# **Calibration Devices CDMR & Progress Status**

# Calibration devices of NectarCAM

**CDMR outcome**

# High priority RIX: flat-field new design to be tested

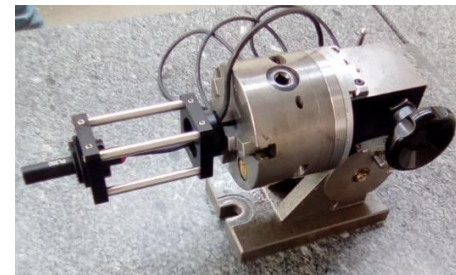
## **One high-priority RIX (42556)**

Finalization of V04 flat-field flasher:

- Mechanical upgrade proposed following Adleshorf campaign (this RIX was expected)
- Action items proposed by panel in line with planned actions at LUPM & IJCLab

- Spare fiber connector: **implemented**
- Humidity sensor + Power-surge / Lightning protection:  
→ AI CTAO: decide if Power-surge / Lightning protection improvements to be mandated.  
→ Better course of action, AI JB: contact Markus to determine if such protections are applied to other components in the center of the MST dish

*Mechanics V03 → V04 outlined in CDMR doc DD187*

- **Laser alignment system** ( $\delta\theta < \text{pixel}$ )
- **Engineered diffusive window** (flatness within 2%)  
*Note: better than requirement = pattern known within 2%*
- **Associated mechanical enclosure**
